**Re: Storm Water Inspection at Taco Bell – Grove City / Franklin County  
Permit #: 4GC03860\*AG**

This letter is written in follow-up to a construction storm water inspection by Alicia Rector and Elizabeth Plefa of the Ohio EPA, accompanied by Scott Stevens, at Taco Bell – Grove City located at 2787 London – Groveport Road on July 12, 2012. The purpose of the inspection was to evaluate compliance with the General Storm Water Permit Associated with Construction Activities. During the inspection, we noted the following:

**Figure 1: South side of site void of silt fence**

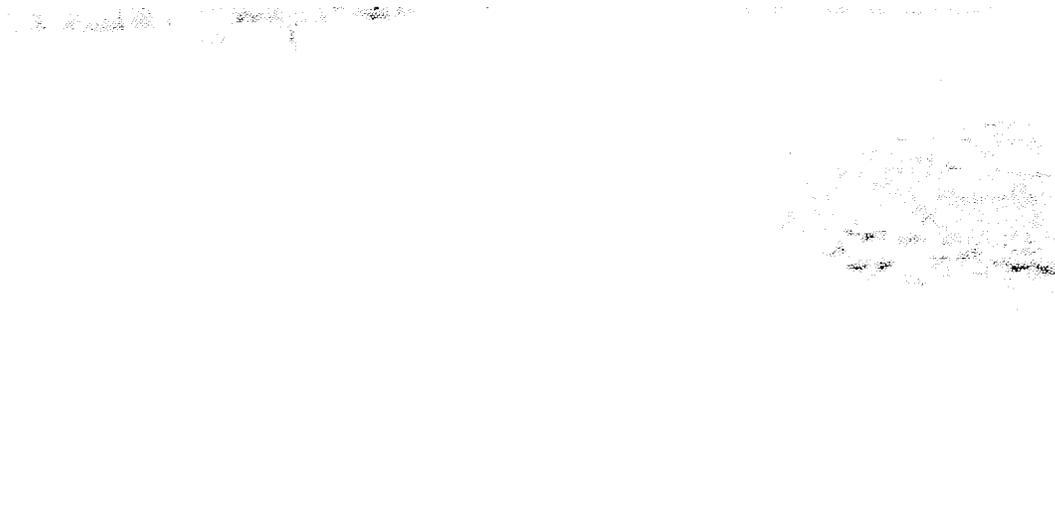
- All sediment controls are required prior to earth disturbing activities. During the inspection our staff noted major earth disturbance with no evidence of sediment controls resulting in a direct violation of your permit. All sediment control must be implemented within three days receipt of this letter (See Figure 1).
- The entrance of the site must be stabilized to minimize off site vehicle tracking (See Figure 2).
- Be aware the General Permit states that all barren areas which remain idle in excess of 21 days must be protected from erosion within seven days of the last earth disturbing activities. In addition, erosion protection must be implemented for all areas of final grade within seven (7) days (Also See Figure 2).
